SERVICE LETTER

No. 783

Piper Aircraft Corporation

Inspection of Air Conditioning System
Capillary Sensor

VIEW LOOKING AFT AT EVAPORATOR UNIT

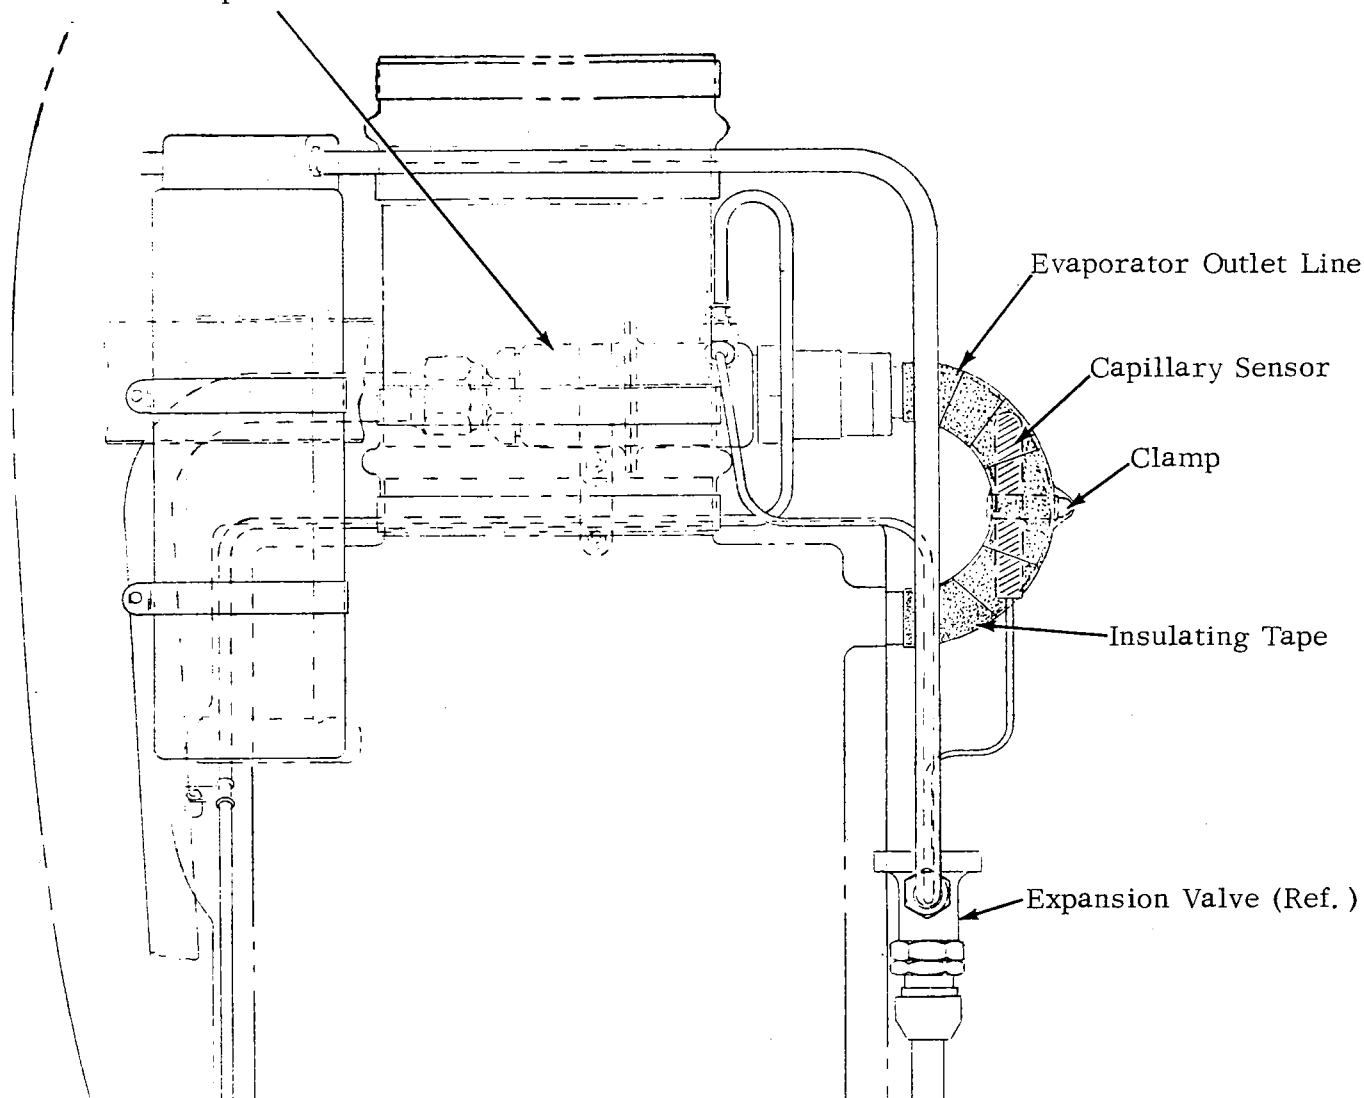
1. Remove access panels from both sides of fuselage nose section to gain access to the evaporator unit.
2. Inspect capillary sensor to determine if it is properly positioned and clamped against the evaporator outlet line as shown above.

- a. If clamp is present and capillary sensor does not protrude above the curvature of the evaporator outlet line, no further action is required.
 - b. If clamp is not present and/or if capillary sensor protrudes above the curvature of the evaporator outlet line, proceed as follows.

1. Carefully remove insulating tape from evaporator outlet line and capillary sensor. Clean tape residue from line and sensor using MEK or acetone.
 2. Secure sensor to line, as shown above, using clamp P/N 454 921 (SAE Type 10 or Breeze #QS100-M10).

3. Apply insulating tape P/N 189 777 (P. T. I. Prestite Insulating Tape 1/8" x 2") over outlet line, capillary sensor and clamp.
3. Reinstall access panels and make proper logbook entry of Service Letter 783 compliance.
